**RE: MUSSEY GRADE ROAD ALLIANCE COMMENTS ON THE 2025 UPDATE OF THE WILDFIRE MITIGATION PLANS OF PG&E, SCE, AND SDG&E**

## **WILDFIRE MITIGATION PLAN COMMENTS ON BEHALF OF THE MUSSEY GRADE ROAD ALLIANCE**

**Figure 2** - SCE's corrected Figure 7-1, showing its predicted residual risk based on its current mitigation plans and its MARS risk model.

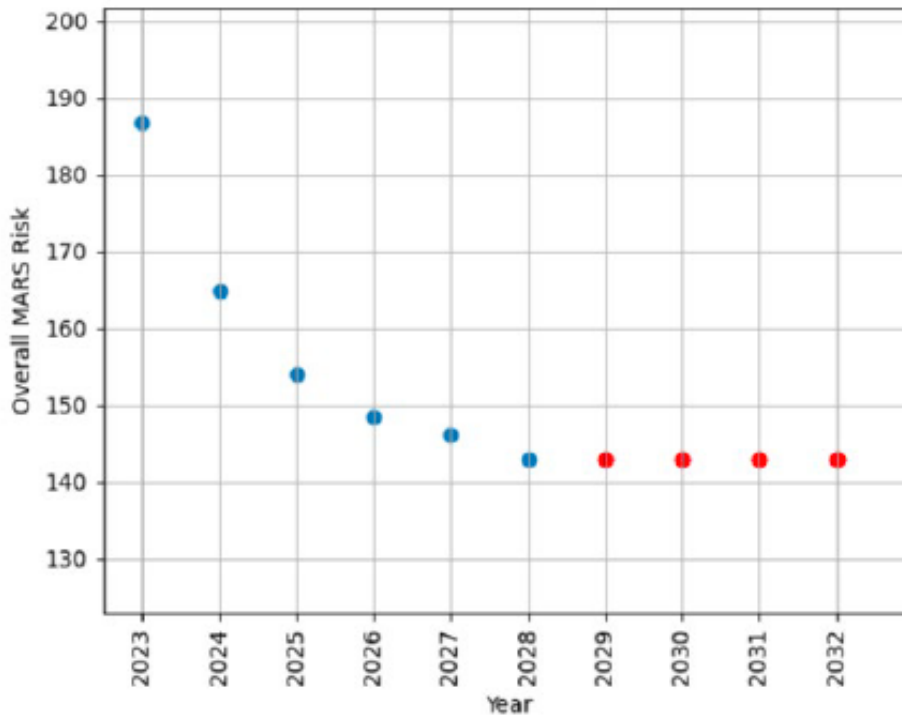
According to SCE's estimates work done between 2023 and 2028 will reduce risk only 23.5% below its 2023 baseline value of 187. It should be pointed out that this relatively modest reduction will be driven by some of the most expensive mitigation that SCE has performed to date.

**Figure 3** - PG&E Figure B.1.1-3 - Risk buydown curve with WDRM v4 versus WDRM v3. The differences are mainly due to the wildfire propagation times extending the area of damage outward from the ignition point.<sup>41</sup>

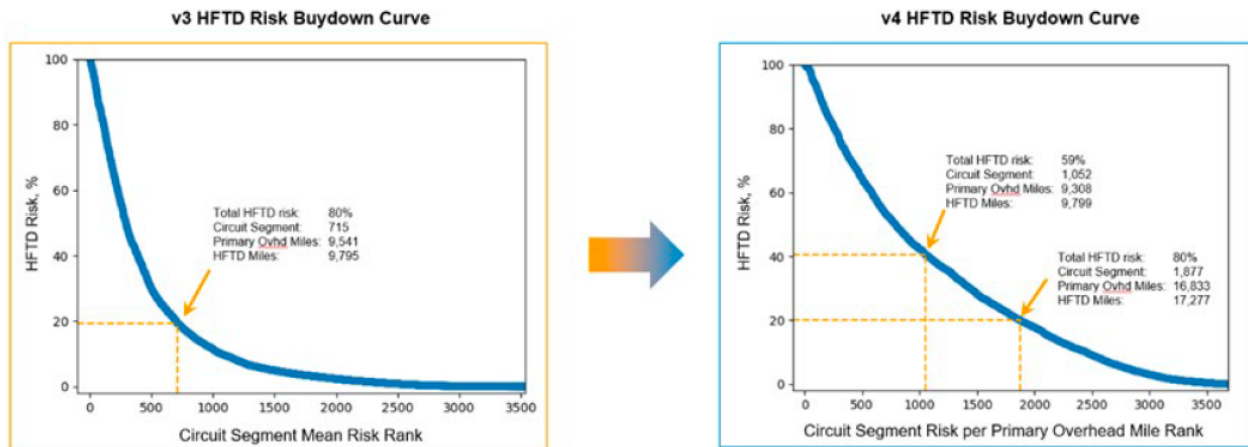
PG&E is moving to its v4 wildfire model which it will implement starting in 2026. PG&E has made a number of improvements in this model, including increasing the Technosylva simulation times to 24 hours. As MGRA predicted, this change 1) increased the overall predicted wildfire risk, and 2) moving the area at risk further out from the point of ignition and reducing the “urbanization” of risk MGRA has been warning about over the past few WMP cycles.<sup>40</sup>

Previously, PG&E had been promising that future updates would lead to relatively modest changes. An exchange from the evidentiary hearings in PG&E’s last GRC made this clear:

**Figure 5** - Figure ACI SCE-23-09b, incorporating the effective lifetimes of covered conductor.

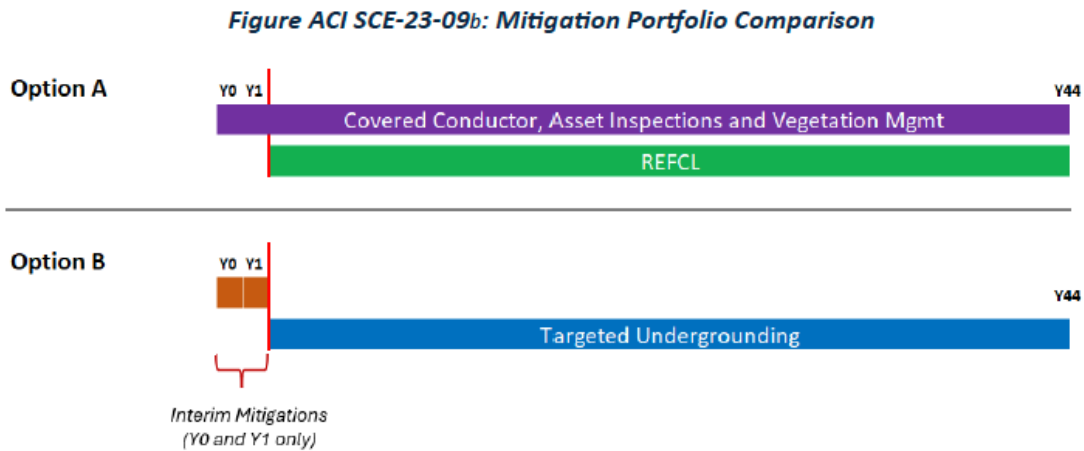
However, SCE’s analysis did not take into account the fact that SCE’s field data imply a current wildfire ignition reduction efficiency of 85% versus the 72% used in the SCE analysis. Using SCE’s analysis spreadsheet as a starting point, MGRA constructed its own analysis using an imputed wildfire reduction efficiency for covered conductor of 85%, but in all other aspects identical to the SCE analysis.<sup>71</sup> This was done by approximating an increase in efficiency of 85/72 in risk reduction. However the mechanism by which this added efficiency is being achieved is not yet understood and it could be possible that it is redundant with protections that would be put in place by REFCL (or conversely that the imputed additional wildfire mitigation efficiency is complementary with REFCL and would therefore provide an even higher level of protection than the 85/72 ratio).

**Figure 6** - PG&E chart of cumulative risk reduction for undergrounding and overhead hardening over the asset lifetime.

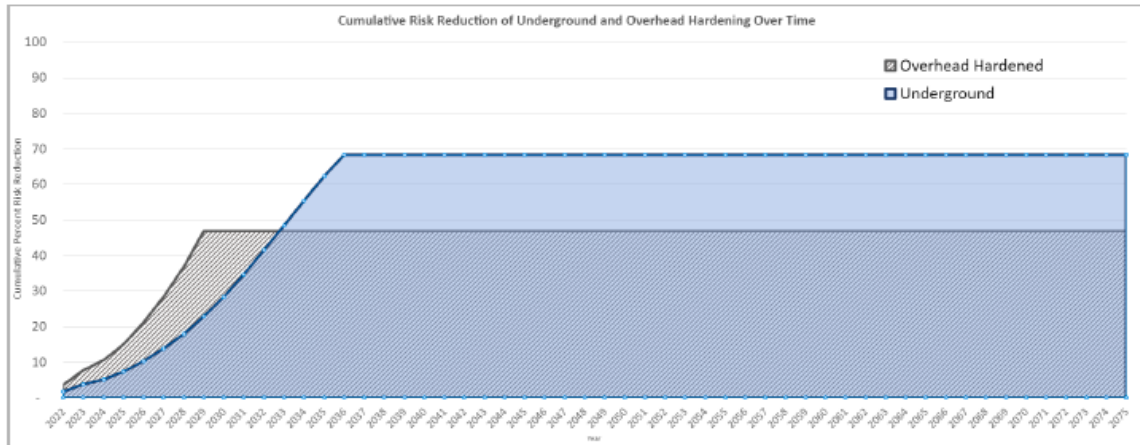
PG&E’s approach suffers from the same shortcomings that the SCE analysis does, specifically that the risk elimination from overhead hardening is much larger than anticipated due to CC efficiency overestimation and lack of incorporating Advanced Technologies such as REFCL, EFD, FCP, etc.

**Figure 8** - SDG&E's Figure 8, showing comparative PSPS impact reduction with and without undergrounding.

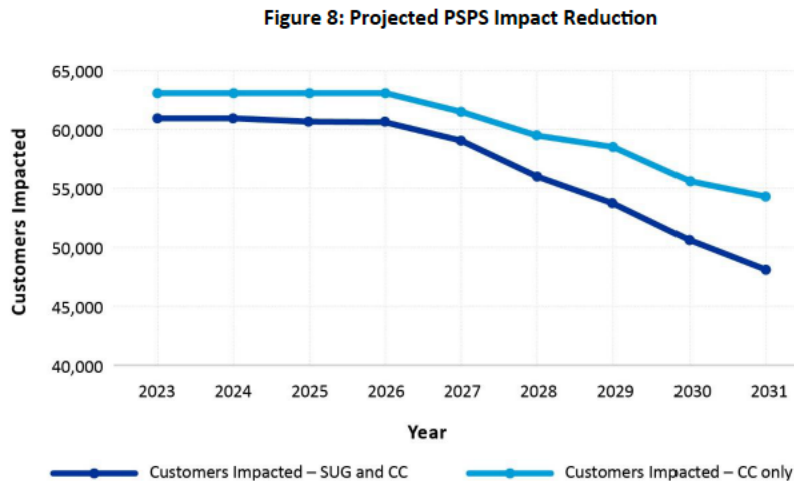
Note that SDG&E's graph's y axis shows a relatively narrow range of customers impacted. In fact, the difference in PSPS impact due to SDG&E's planned undergrounding program would provide only a 18% improvement over covered conductor alone by 2031.<sup>84</sup> Hence, reduction of PSPS impacts provides a weak support for a very expensive undergrounding program.

**Figure 9** - SDG&E Figure 12, purporting to show the decrease in hardening efficiency over time for covered conductor and for traditional hardening. MGRA analysis shows that this graph is in error.

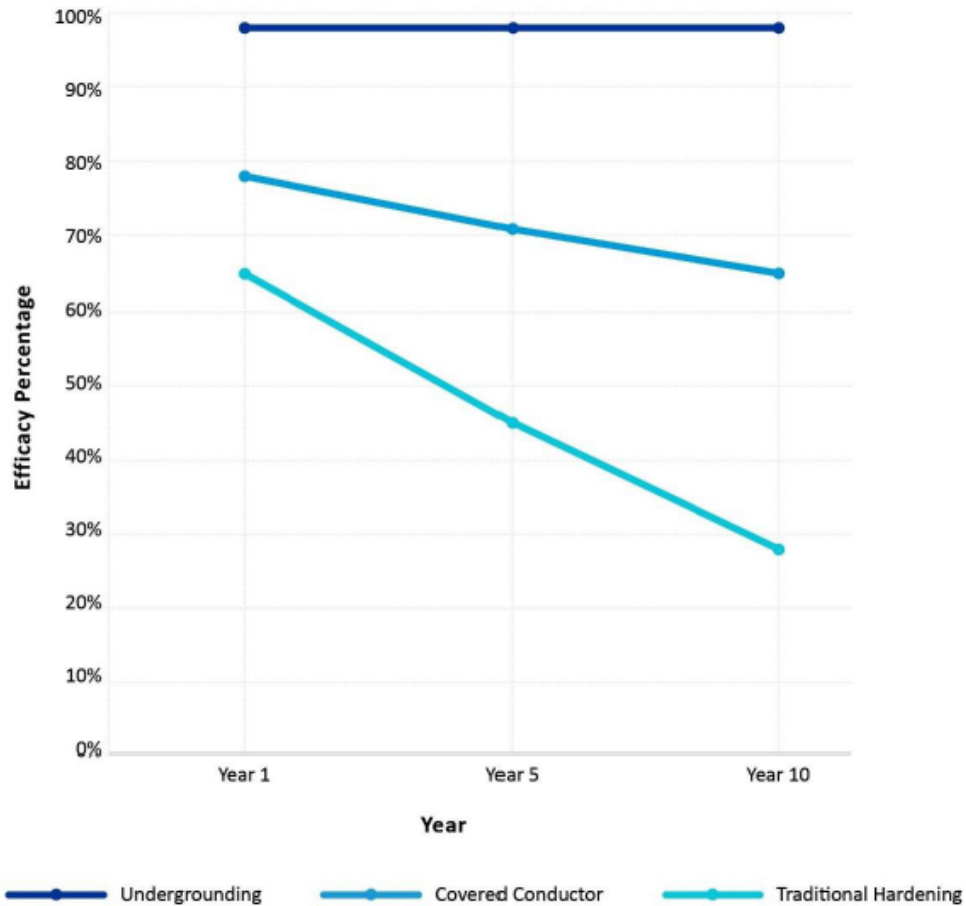
MGRA was able to obtain the data that SDG&E used to derive its estimates and SDG&E's calculations.<sup>92</sup> As MGRA shows in its modified spreadsheets (SDGE Response MGRA-SDGE-2025WMP-04\_Q2.1-2022-jwm.xlsx), it appears that the root of SDG&E's result is mathematical and statistical error.

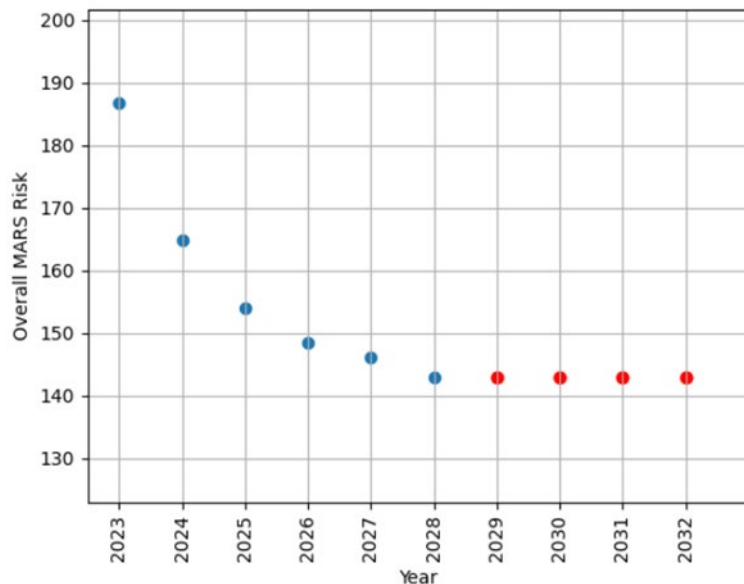
Regarding Redlines to SCE’s 2023-2025 Wildfire Mitigation Plan  
The modification to Figure 7-1, Projected Overall HFRA risk shows the residual MARS risk after 2028 increasing from 80 in the 2023-2025 WMP to 150 in the WMP 2025 update. What is the cause of this increase in residual risk?

SCE’s updates to its risk models for the WMP 2025 update, which are described in Chapter 1, include changes to both Probability of Ignition (POI) and consequence values (Technosylva WRRM 7.6). Both of these changes increased baseline residual risk. For example, SCE’s refresh of fuel maps increased overall consequence values and also filled in previously zero values in Technosylva WRRM 6.0 values.

Additionally, SCE’s updated version of Figure 7-1 included certain calculation errors. SCE has corrected this in errata submitted to OEIS on April 16, 2024. For reference, here is the corrected version of Figure 7-1:
